Access Compliance Report

Public Rights-of-Way (Curb Ramps)

Intersection ID: 9830	Main Street: ETHEL_GUEST_LN	Cross Street: GERALDINE_POWE_DR	Location: SW
ADA ID: B226E3315869	Ramp Type: BlendTrans1	Initial Pass/Fail: Fail	Overall Compliance: No
		Severity Score: 25

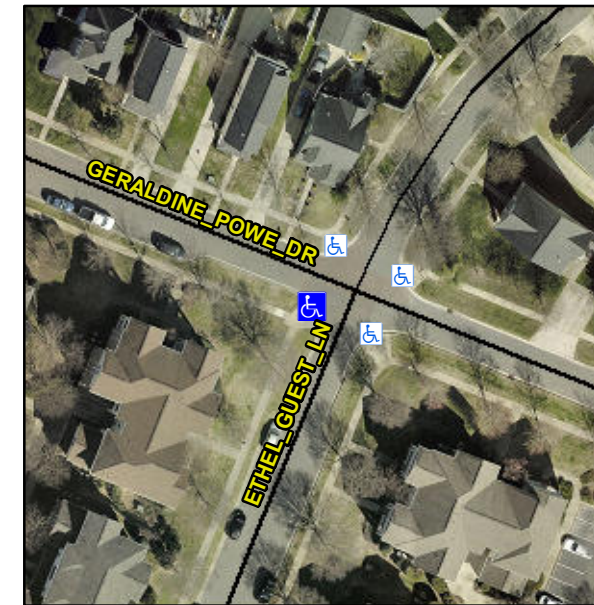
Not Found, R304.5.3

Compliance	Description	Data	Compliance	Description	Data
N/A	Ramp Length (in)	126.0	Yes	BlendTrans Slope (%)	0.1
Yes	Ramp Width (in)	60.5	No	BlendTrans XSlope (%)	8.4
N/A	Flare Type LT	N/A	N/A	Flare Type RT	N/A
N/A	Flare Slope LT (%)	N/A	N/A	Flare Slope RT (%)	N/A
N/A	Flare Traversable LT?	N/A	N/A	Flare Traversable RT?	N/A
N/A	Landing Length (in)	N/A	N/A	DWS Provided?	N/A
N/A	Landing Width (in)	N/A	N/A	DWS Contrast?	N/A
N/A	Landing Slope (%)	N/A	N/A	DWS Length (in)	N/A
N/A	Landing X Slope (%)	N/A	N/A	DWS Full Width?	N/A
N/A	Landing Curb? (Y/N)	N/A	N/A	DWS Offset (in)	N/A
N/A	Shared Landing?	N/A			
N/A	Gutter Ponding?	N/A	N/A	Gutter Slope (%)	N/A
N/A	Gutter Lip Ht (in)	N/A	N/A	Gutter X Slope (%)	N/A
N/A	Painted X Walk1?	No	N/A	Painted X Walk2?	No
	X Walk 1 Direction	To E		X Walk 2 Direction	To N
	X Walk 1 Width (in)	N/A		X Walk 2 Width (in)	N/A
	X Walk 1 Slope (%)	1.3		X Walk 2 Slope (%)	0.2
	X Walk 1 X Slope (%)	5.6		X Walk 2 X Slope (%)	3.5

N/A	Ramp inside XWalk1?	N/A	N/A	Ramp inside XWalk2?	N/A
	Road Slope (%)	7.6		Clear Space?	N/A
	Road X Slope (%)	0.3	N/A	Clear Space to XWalk (in)	N/A
N/A	Any Obstructions?	N/A	N/A	Storm Grate/Utility Hazard?	N/A
	Obstruction Type			Storm Grate/Utility Type	
		N/A			N/A
			Yes	Surface Condition? (G/P)	Good
			No	Curb Slope (%)	15.2

Remove & Replace Curb Ramp With Two New Directional Ramps or Equivalent.
